FIGURE 6.2-2 UNIT ORGANIZATION

Justification for changes to Technical Specifications 4.5.3.2 footnote and 4.1.2.3.2 footnote.

KG&E requests these changes to be incorporated into Wolf Creek's Technical Specification for issue with the full power license.

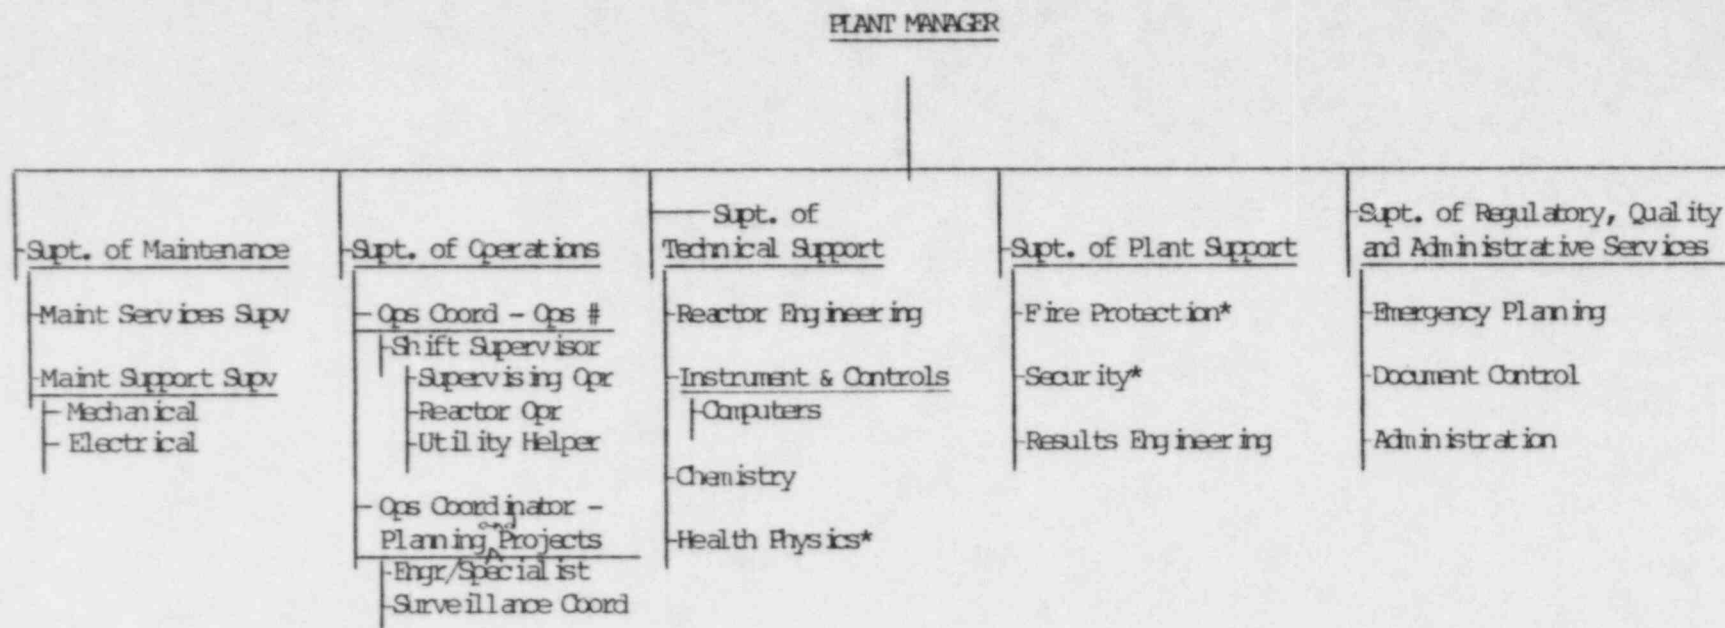
See attached for  
revised version.
